NPL 2000-0341

**DOCKETS 50-266 AND 50-301**  
**SUPPLEMENT 4 TO APPLICATION FOR AMENDMENT TO**  
**FACILITY OPERATING LICENSE APPENDIX A:**  
**TECHNICAL SPECIFICATIONS IMPROVEMENT PROJECT**  
**RESPONSE TO RAI ON ITS SECTION 3.8**  
**POINT BEACH NUCLEAR PLANT, UNITS 1 AND 2**

**DOCKETS 50-266 AND 50-301**  
**RESPONSE TO REQUEST FOR ADDITIONAL INFORMATION**  
**TECHNICAL SPECIFICATIONS IMPROVEMENT PROJECT SECTION 3.8**  
**POINT BEACH NUCLEAR PLANT UNITS 1 AND 2**

Insert 3.8.1-5:

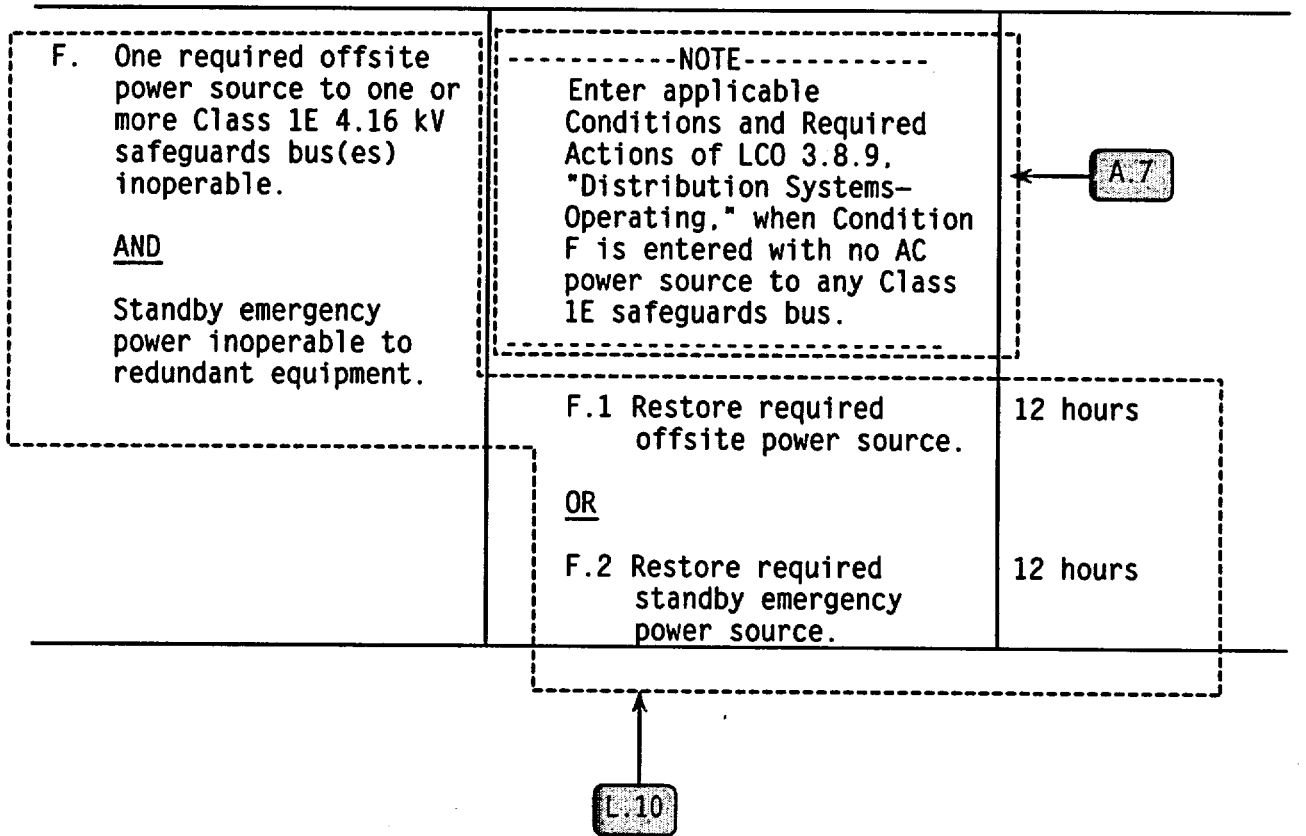
The proposed ITS includes LCO 3.8.1, Condition C. This condition would allow buses A05 and A06 in the same unit, or buses 1A05 and 2A06 to be without offsite power for 24 hours. Neither of these plant conditions is allowed by the CTS, and represent a less restrictive change. It is the staff's view that the DOCs associated with this change do not provide an adequate justification for the change. The justifications provided paraphrase the NUREG Bases, but fail to address why the change is acceptable from a plant-risk perspective. The licensee is requested to revisit the proposed change with a view towards providing a more adequate justification.

DOC L.06 has been revised to include a more complete discussion of the acceptability of the proposed ITS Condition C allowed outage time from a risk perspective. The time proposed for restoration of the offsite source of power is sufficient to restore offsite power in most cases while short enough to account for the importance of the offsite, preferred power source. During this condition, onsite sources of power are not affected such that the safety function of all required equipment will continue to be performed. The allowed outage time recognizes the most likely causes for the inoperability of offsite power are related to problems with the offsite power grid. In these cases, removing a unit's generation from the grid may further exacerbate the condition, making it more difficult, and take a longer time, to restore offsite power thus further impacting the operability of required onsite systems. Thus, 24 hours is a reasonable time to correct the condition.

<p>C. Required offsite power source to buses A05 and A06 on the same unit inoperable.</p> <p><u>OR</u></p> <p>Required offsite power source to buses 1A05 and 2A06 inoperable.</p>	<p>C.1 Restore required offsite power source(s) to OPERABLE status.</p>	<p>24 hours</p> <div data-bbox="1279 373 1421 525"> <p>New</p> <p>↑</p> <p>L.6</p> </div>
<p>D. One or more required offsite power source(s) to one or more required Class 1E 4.16 kV bus(es) inoperable.</p> <div data-bbox="259 1249 516 1438"> <p>CTS 15.3.7.B.1.f 15.3.7.B.1.g 15.3.7.B.1.h</p> <p>↑</p> <p>A.11</p> </div>	<p>D.1 Declare required feature(s) supported by the inoperable required offsite power source inoperable when its required redundant feature(s) is inoperable.</p> <p><u>AND</u></p> <p>D.2 Restore required offsite power source(s) to OPERABLE status.</p>	<p>12 hours from discovery of Condition D concurrent with inoperability of redundant required feature(s)</p> <div data-bbox="1209 1018 1372 1176"> <p>New</p> <p>↑</p> <p>L.4</p> </div> <p>7 days</p> <p><u>AND</u></p> <p>14 days from discovery of failure to meet LCO</p> <div data-bbox="1421 1302 1518 1449"> <p>New</p> <p>↑</p> <p>M.2</p> </div> <div data-bbox="1421 714 1529 808"> <p>⚠</p> <p>RAI 3.8.1-8</p> </div>

B  
RAI 3.8.1-9

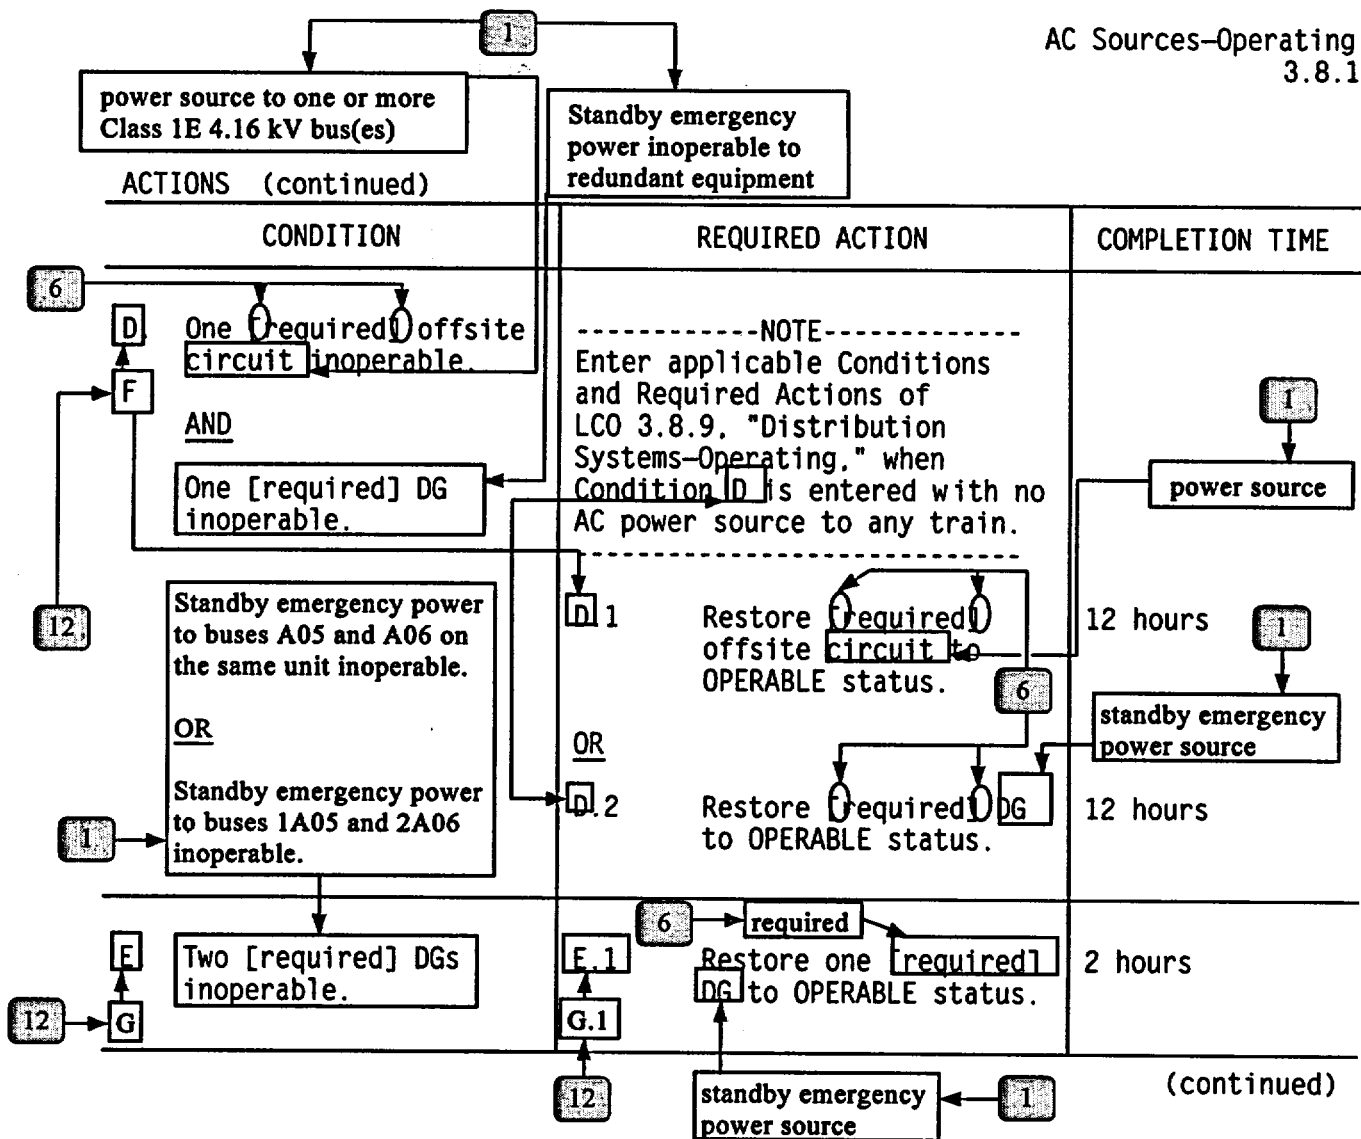
Required Actions A.1 and A.2 address the opposite unit's X03 transformer and the gas turbine, respectively. This appears to be redundant to the LCO, since the plant condition addressed in Actions A.1 and A.2 is specifically allowed by the LCO. This is potentially confusing. Consideration should be given to revising the LCO to be consistent with the Bases discussion as the normal power alignment, and the allowed alternate alignment addressed in Required Actions A.1 and A.2.
